Access Compliance Report

Public Rights-of-Way

(Curb Ramps)

Intersection ID: N/A	Main Street: GARDNER_LN	Cross Street: ALEXANDER_CREST_LN	Location: NW
ADA ID: 259CFFEAD426	Ramp Type: PerpDiag	Initial Pass/Fail: Fail	Overall Compliance: No
Codes/Mitigation Info/Possible Solution		Field Measurements/Component Compliance

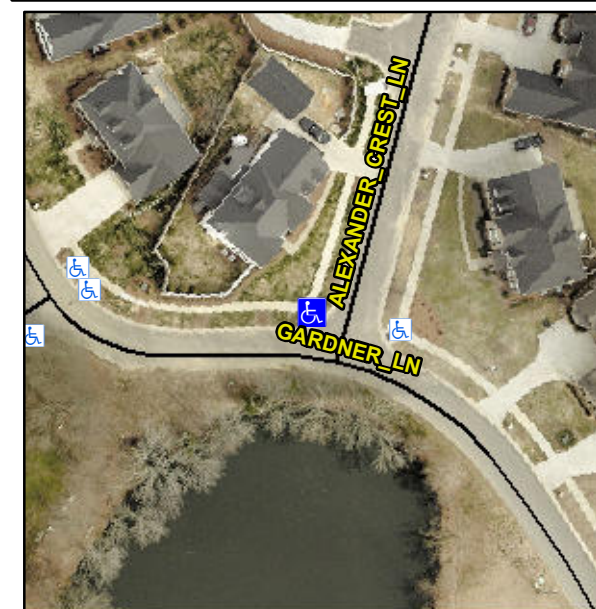
Not Found, R304.2.2, R304.5.3

Compliance	Description	Data	Compliance	Description	Data
N/A	Ramp Length (in)	97.0	No	Ramp Slope (%)	8.9
Yes	Ramp Width (in)	48.0	No	Ramp XSlope (%)	3.1
N/A	Flare Type LT	N/A	N/A	Flare Type RT	N/A
N/A	Flare Slope LT (%)	N/A	N/A	Flare Slope RT (%)	N/A
N/A	Flare Traversable LT?	N/A	N/A	Flare Traversable RT?	N/A
N/A	Landing Length (in)	N/A	N/A	DWS Provided?	N/A
N/A	Landing Width (in)	N/A	N/A	DWS Contrast?	N/A
N/A	Landing Slope (%)	N/A	N/A	DWS Length (in)	N/A
N/A	Landing X Slope (%)	N/A	N/A	DWS Full Width?	N/A
N/A	Landing Curb? (Y/N)	N/A	N/A	DWS Offset (in)	N/A
N/A	Shared Landing?	N/A			
N/A	Gutter Ponding?	N/A	N/A	Gutter Slope (%)	N/A
N/A	Gutter Lip Ht (in)	N/A	N/A	Gutter X Slope (%)	N/A
N/A	Painted X Walk1?	No	N/A	Painted X Walk2?	No
	X Walk 1 Direction	To S		X Walk 2 Direction	To E
N/A	X Walk 1 Width (in)	N/A	N/A	X Walk 2 Width (in)	N/A
	X Walk 1 Slope (%)	0.8		X Walk 2 Slope (%)	2.1
	X Walk 1 X Slope (%)	3.2		X Walk 2 X Slope (%)	0.9

Remove & Replace Curb Ramp With Two New Directional Ramps or Equivalent.
